Camden Residents' Action Group

Re: DA 2021/77/1

4 O'Keefe Drive, 57E Banfield Drive and 73 Banfield Drive ORAN PARK
*Concept DA for approval of site-specific building height development standards on
66 residential lots and construction of 3 single storey dwellings*

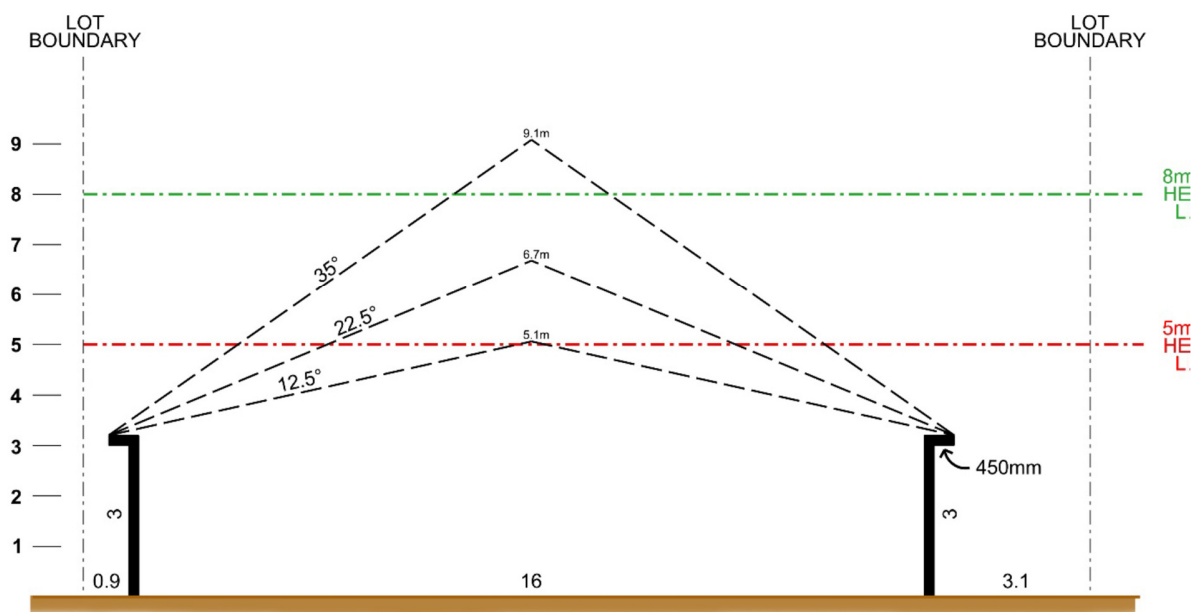
We submit therefore that 8m as requested is much closer to two storeys than the one storey limit imposed by the exemption guidelines.

The SEE (p. 1) also claims that the 5m building height limit specified by the Growth Centres SEPP 2006 does not allow compliance with the intended site-specific development controls in the DCP.

To support this claim the SEE (p. 13) provides the following diagram indicating the key controls.

Of course, the wider the house the higher the roof needs to be to attain the required pitch. The assumption is that the whole building will be under one continuous roof, rather than having the roof form broken up, or even having the garage under a separate roof.

A lateral approach seeking a finer grained low-scale, more traditional and less dense residential character is needed to reconcile the required roof-pitch to the height constraint. It is concerning that only one design approach is cherry picked to prosecute the argument for a 37.5% increase in the height limit.
